2. Response to Comments

COMMENT O7 - Tim Brick (Arroyo Seco Foundation) (2 pages)

O7. Response to Comments from Tim Brick of the Arroyo Seco Foundation, submitted via email March 3, 2023.

BROOKSIDE GOLF COURSE IMPROVEMENTS PROJECT

Attachment B: Historic Photographs of Brookside Golf Course

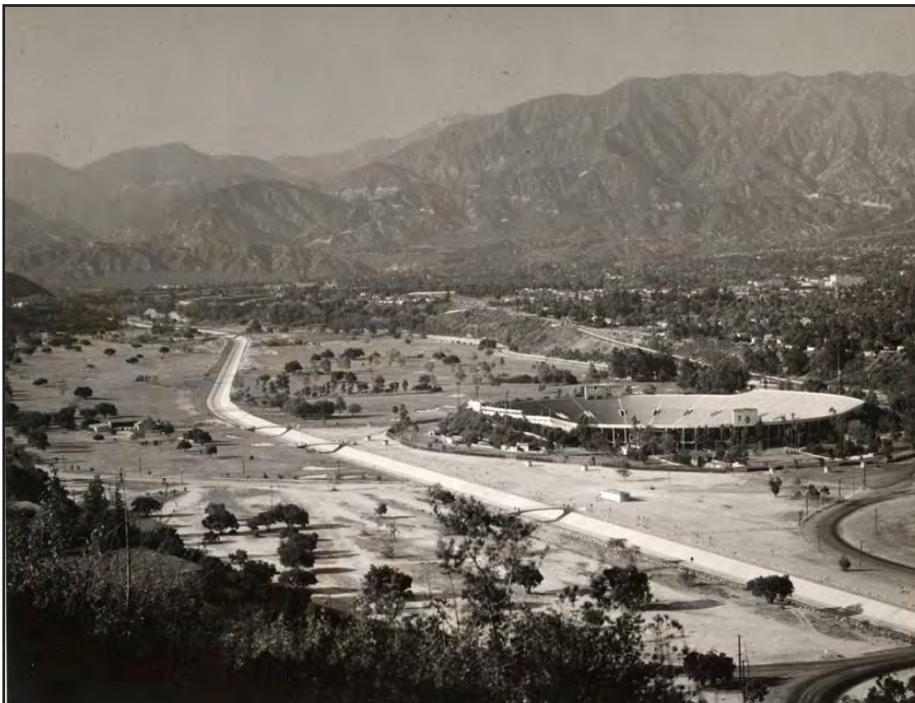
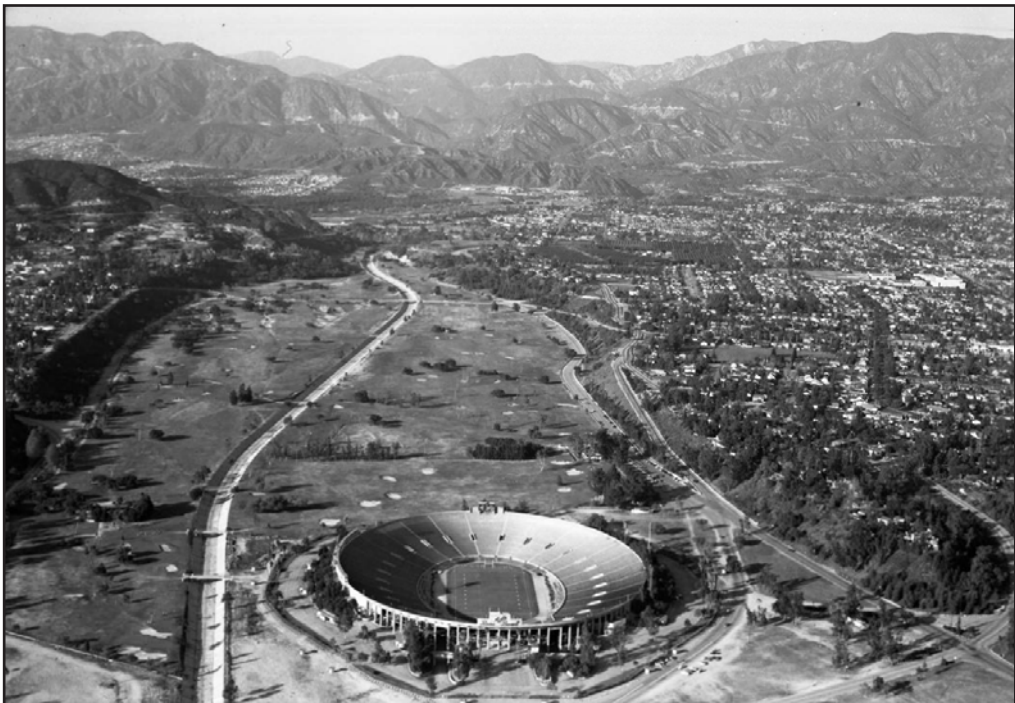
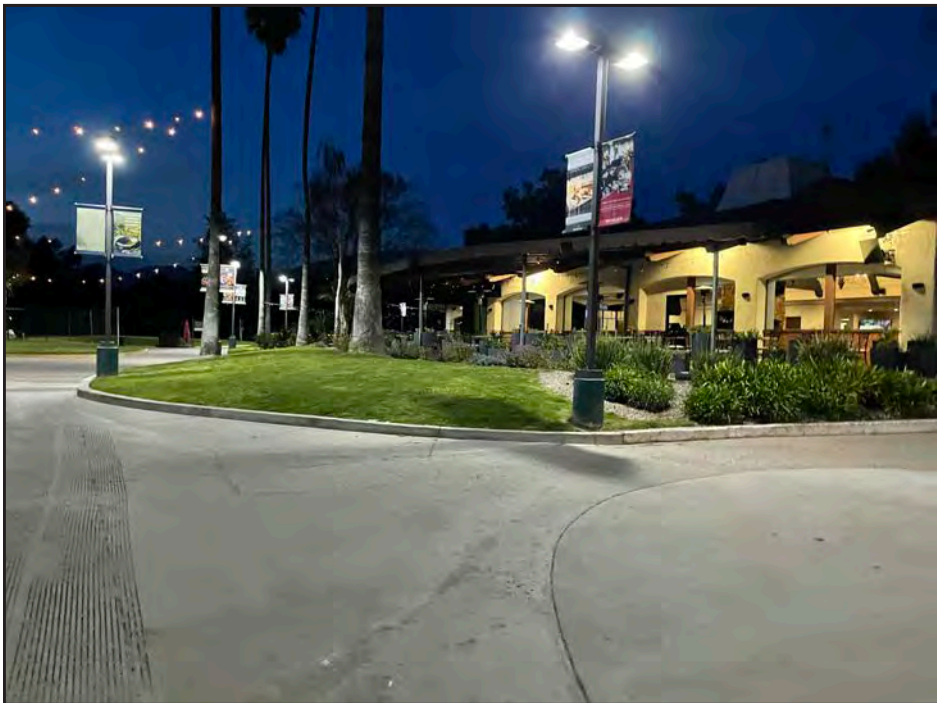
- O7-5 The commenter states that the IS/MND fails to adequately address the elements of the Project stated in response O7-4. Please see previous response. Additionally, the analysis contained in the IS/MND appropriately assumes the existing conditions present at the site, and not former natural conditions that were present before the development of the golf course, 100 years ago (see Attachment B, *Historic Photographs of Brookside Golf Course*).

Attachment D: Potential Locations of Trees to be Removed

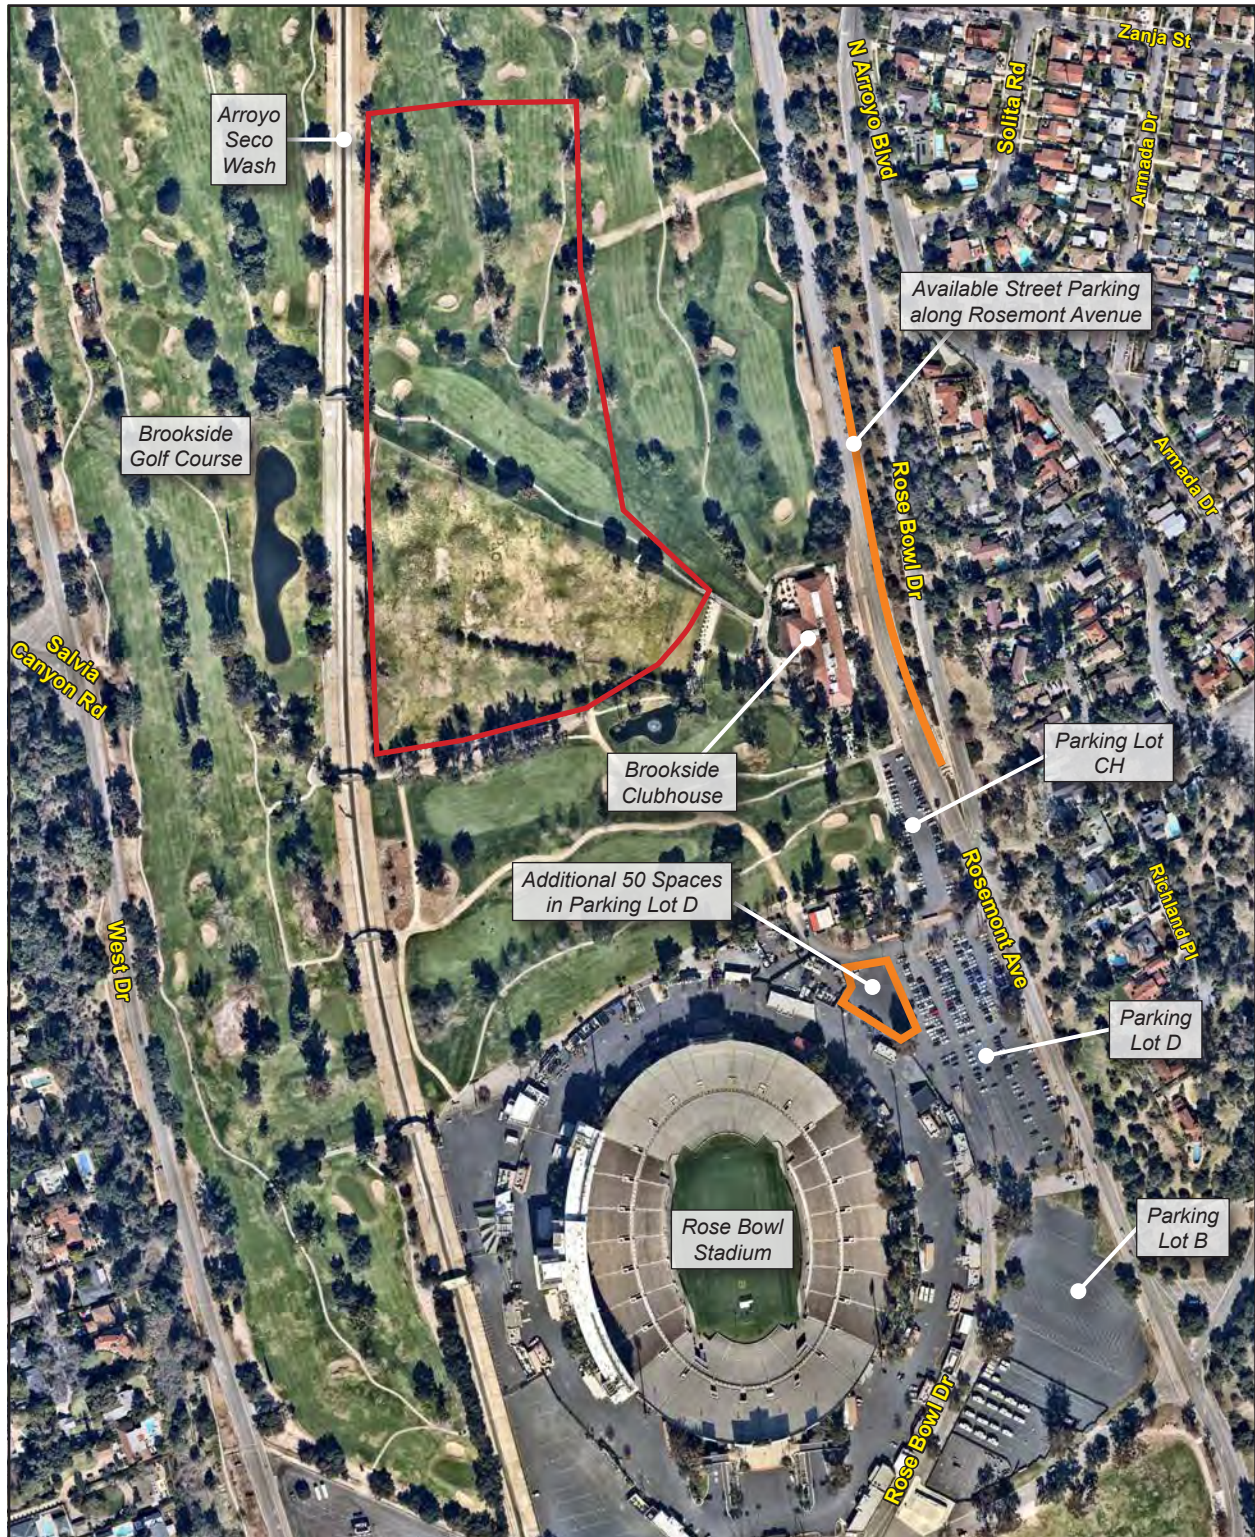
- O8-4 This comment states that LVAA is concerned with the amount of trees that would be cut down for the Project. Please see Topical Response 3, *Tree Removal and Wildlife*, regarding the procedures that would be taken by the RBOC to minimize potential impacts to trees within the Project Site.

- O10-1 The commenter expresses concern with the trees that would be removed from the Project Site. Please see Topical Response 3, *Tree Removal and Wildlife*, regarding the procedures that would be taken by the RBOC to minimize potential impacts to trees within the Project Site.

- O12-1 The commenter is concerned with the number of trees that would be removed for the project. The commenter asked if the trees that are removed would be replaced. Please see Topical Response 3, *Tree Removal and Wildlife*, regarding the procedures that would be taken by the RBOC to minimize potential impacts to trees within the Project Site.

As part of the reorientation of the driving range, some trees could be removed and/or relocated, which would be subject to review and approval by the City's Urban Forestry Advisory Committee (UFAC), and the City Manager. Surficial grading would be required (no excavation) over the total approximately 16-acre Project Site. All soils would be balanced onsite, and no soil export would be required. Consistent with all other Rose Bowl construction and production delivery, any construction vehicles entering the area would use the Mountain/Seco exit off I-210 for ingress and egress.
